United States Nuclear Regulatory Commission

Public Meeting with NEI, EPRI/MRP, and
Industry to Present the

First Revised NRC Order EA-03-009

March 2, 2004

Penetration Nozzle Inspection Coverage

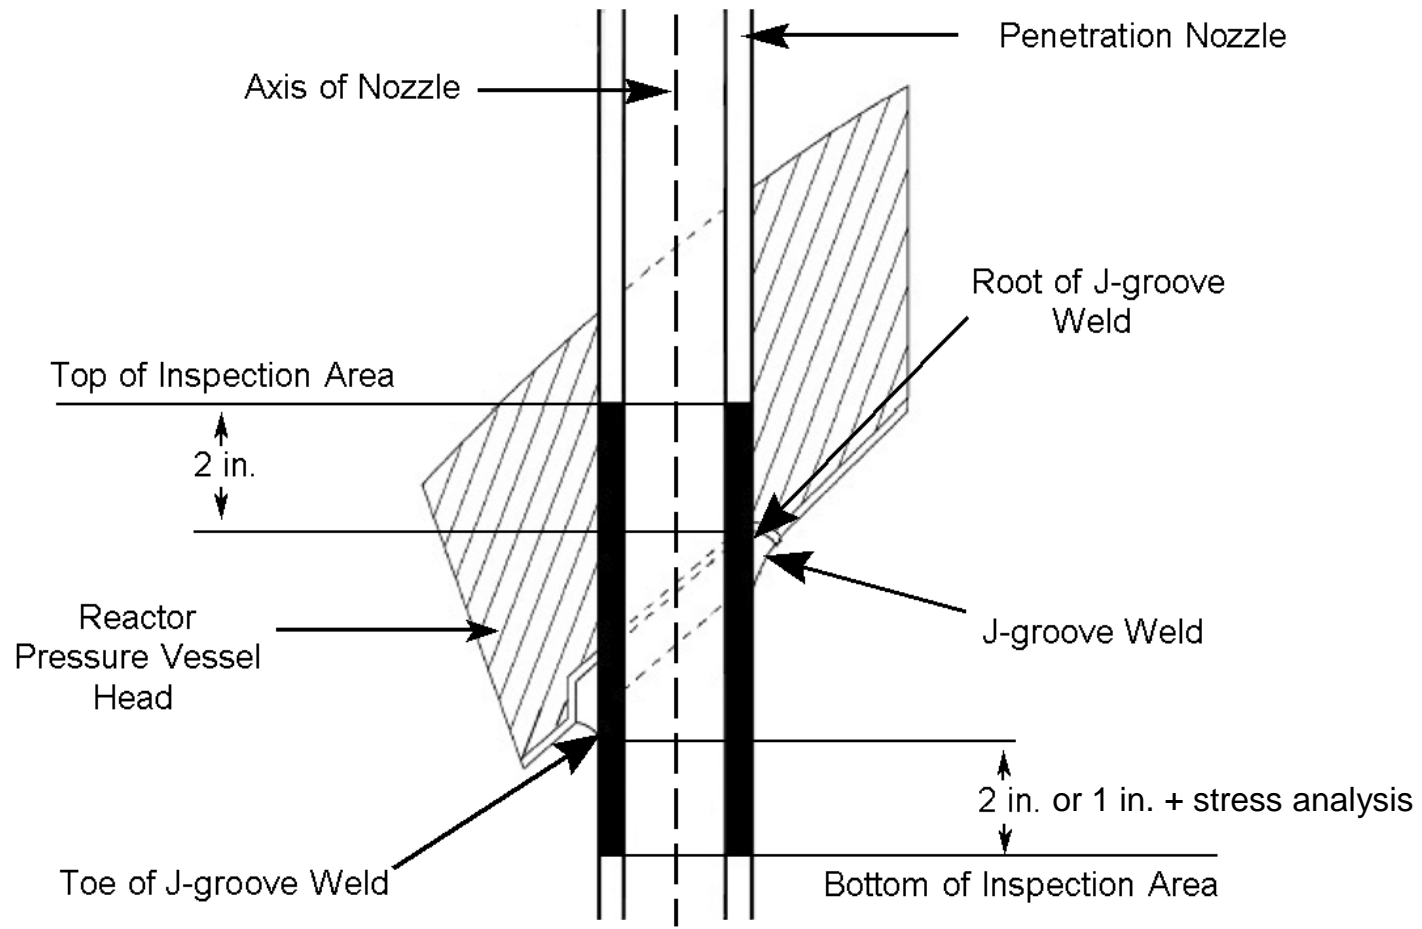
- Originally the Order required inspection from 2 inches above the J-groove weld to the bottom of the nozzle.
- The First Revised Order requires inspection from 2 inches above the J-groove weld to 2 inches below the J-groove weld (or the bottom of the nozzle if less); OR
- From 2 inches above the J-groove weld to 1.0 inches below the J-groove weld and including all RPV head penetration nozzle surfaces that have an operating stress (residual and normal stresses) of 20 ksi tension or greater.
